CEDAR BROOK
66-LOT SUBDIVISION & PUD
TAX MAP T2S R1W 30CD
TAX LOT 13400
SHERWOOD, OREGON

SITE PLAN WITH
HOUSES AND PARKING

Exhibit M

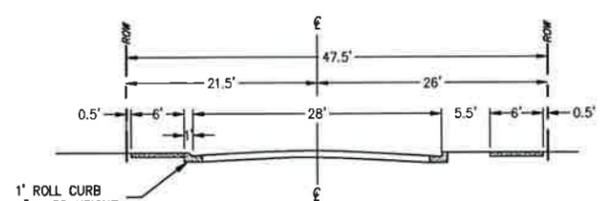
Handwritten: * - Fire Hydrant
